TD0503019S2

DAB-FM Radio

RF-D1EB

**To inform to change in the form of parts supply
Please use this supplement manual together with the service
manual for Model No. RF-D1EB, Order No. TD0406036C2.**

A MAIN P.C.B.

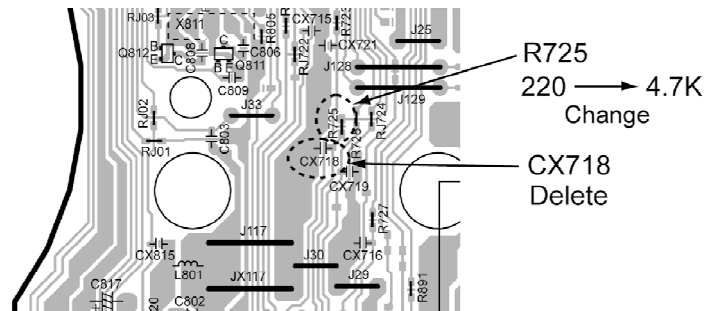
Ref No.	Change Parts No.		Part Name & Description	Remarks
	(Original)	(New)		
RESISTOR				
R725	D0GB221JA008	D0GB472JA008	RESISTOR	(T) Change

- Countermeasure for the consumption current of the unit in power OFF condition.

1. Parts type changed
